Notice of Allowability

10/015,848

EXAMINER'S AMENDMENT

FIG. 4

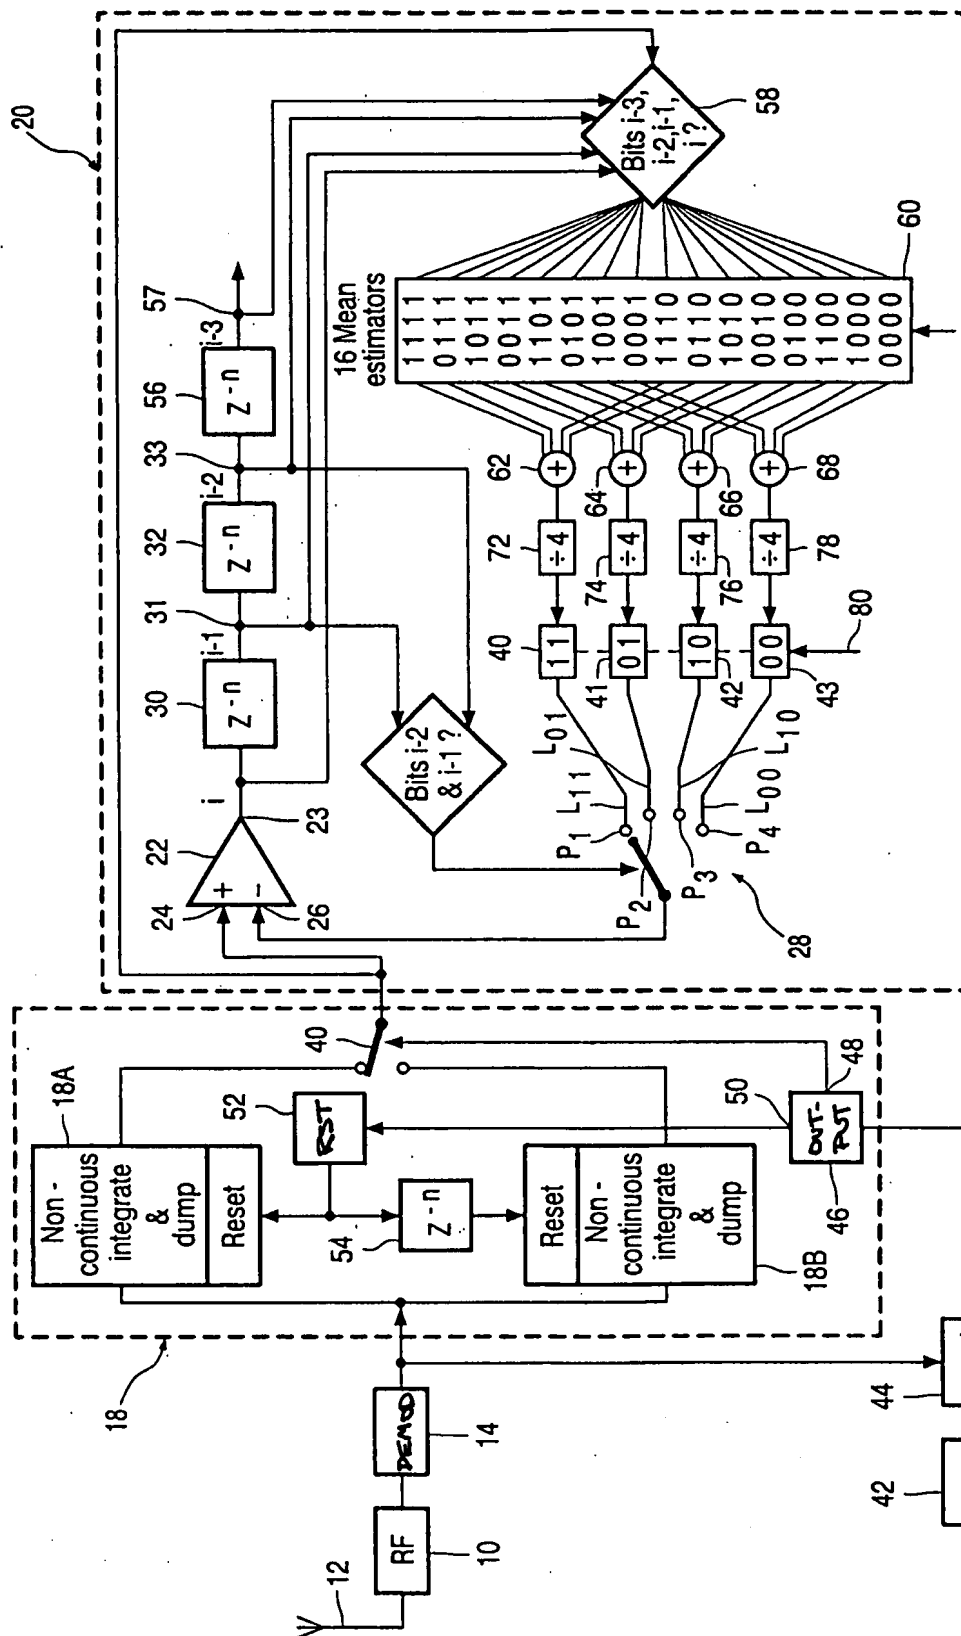
- a. Clean drawing sheets (3/6, fig. 4 and 6/6, fig. 7) submitted July 6, 2005 having every reference block labeled as attached.

In order to avoid abandonment of the application, applicant must make these above agreed upon drawing changes.
